The analysis performed in support of an... The site is located north of Eastonville Falcon Market Place/Eastonville Road Figure 1.

The following memorandum has been prepared for the County as required. The purpose is to confirm that the currently proposed gas station & convenience store use is in conformance with the approved TIS.

**RE: Owl Place Commercial / Traffic Impact Study Addendum
El Paso County, Colorado**

Figure 1 – Site Location

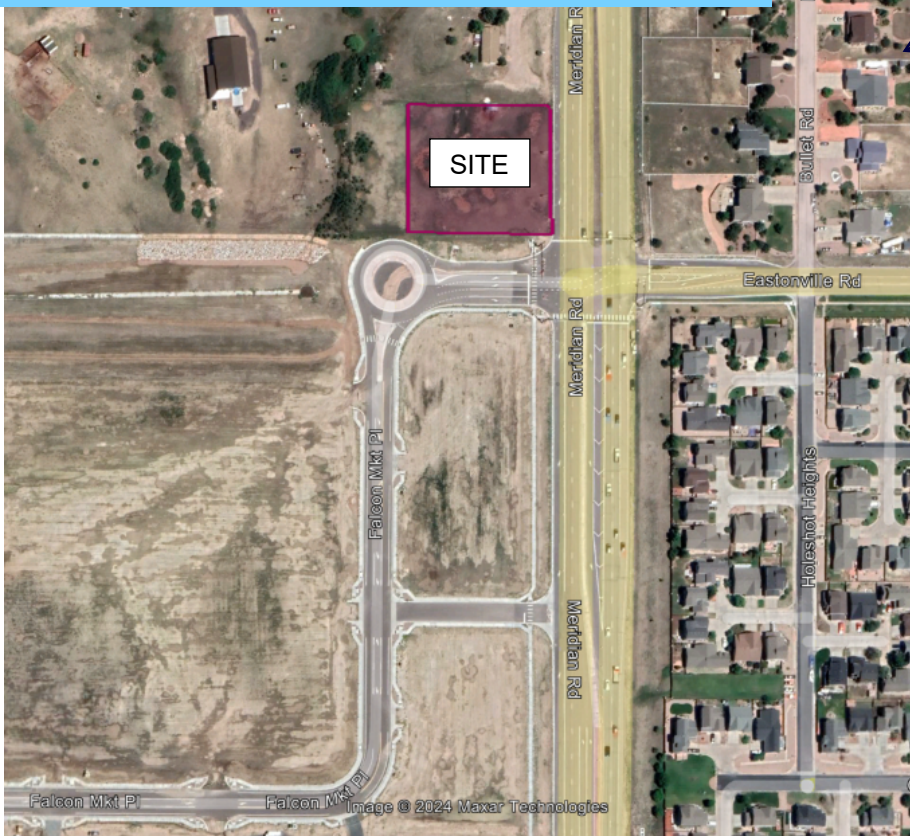
Please provide north arrow and scale information.

Figure 2 – Owl's Place Commercial

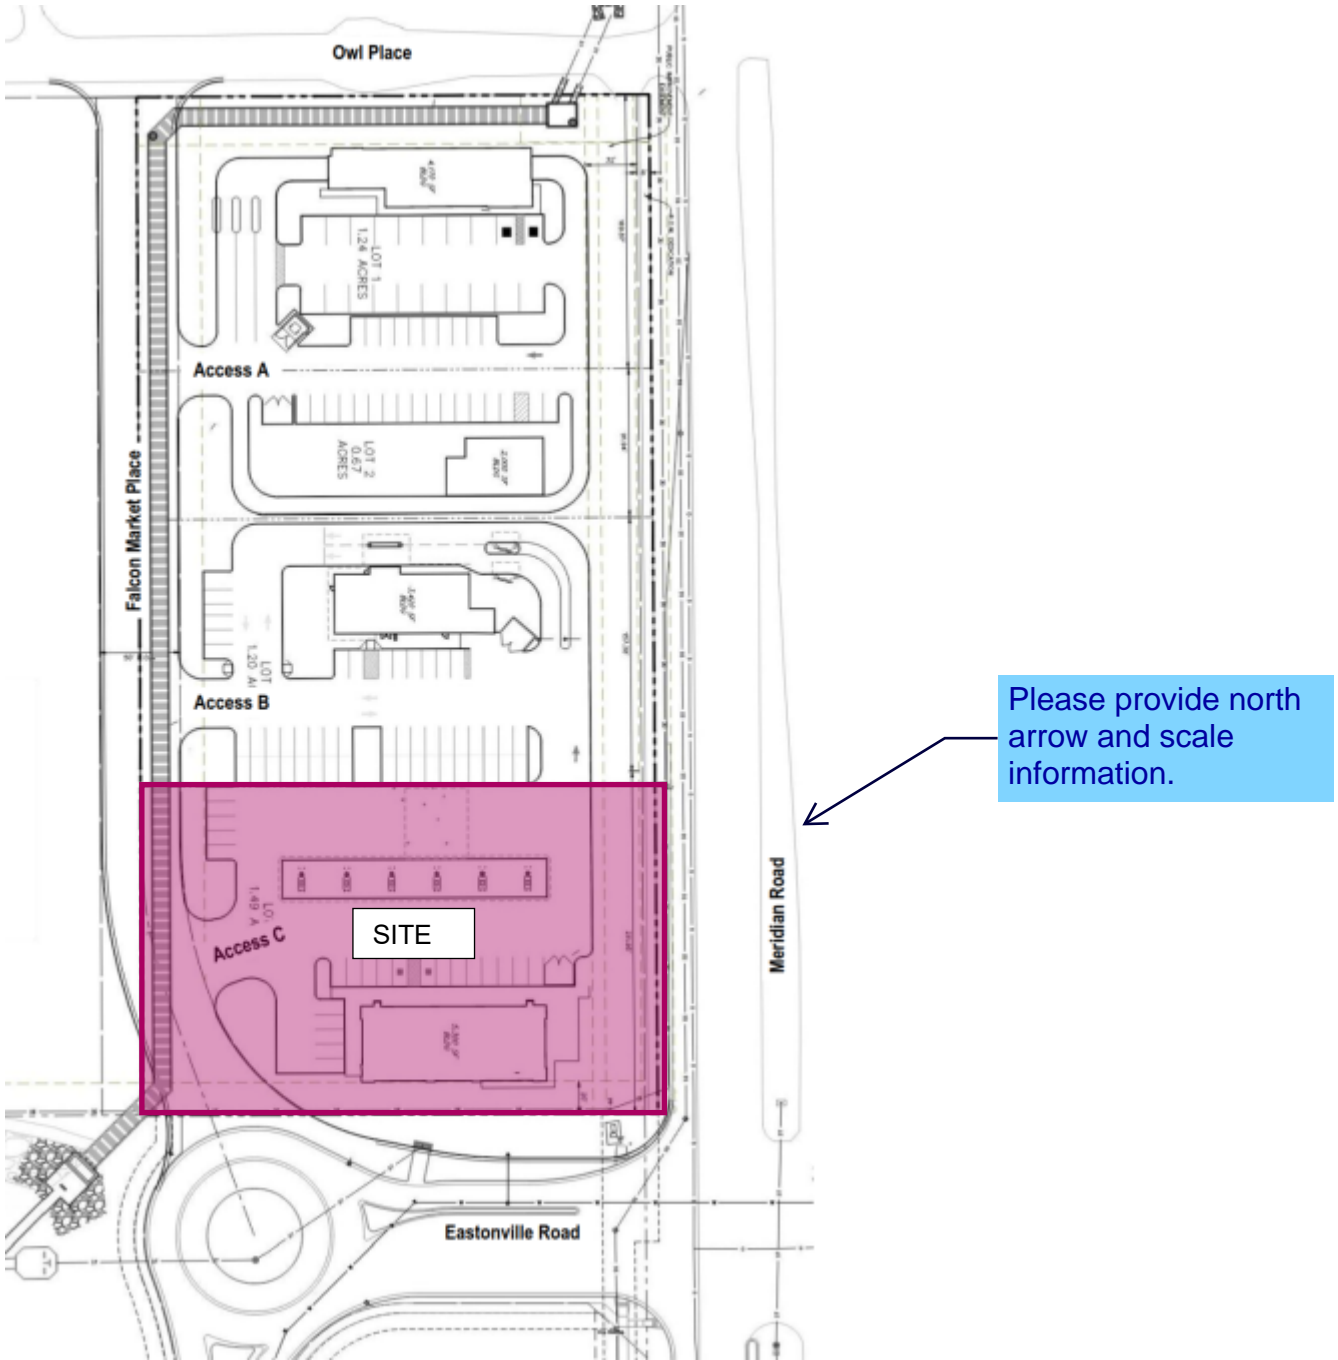
State the actual number of ADT trips and peak hour that the development will generate based on the ITE

Figure 3 – Owl's Place Commercial

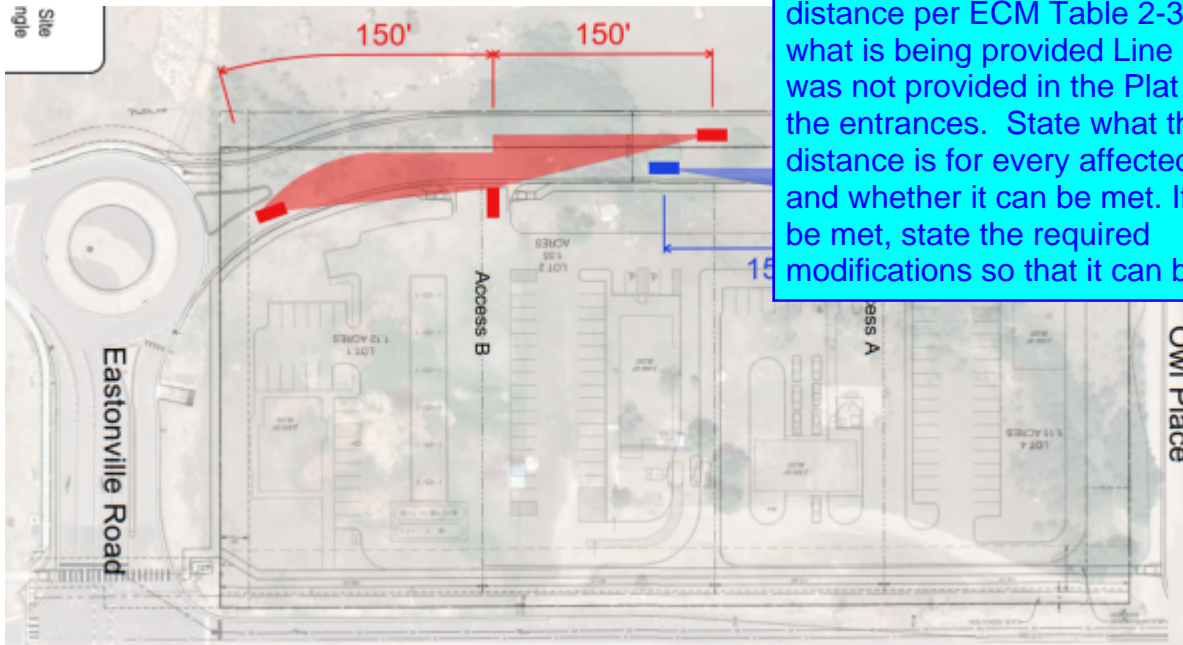
State the required entering sight distance per ECM Table 2-35 and what is being provided Line of Sight was not provided in the Plat TIS for the entrances. State what the sight distance is for every affected access and whether it can be met. If it cannot be met, state the required modifications so that it can be met.

Please provide north arrow and scale information.
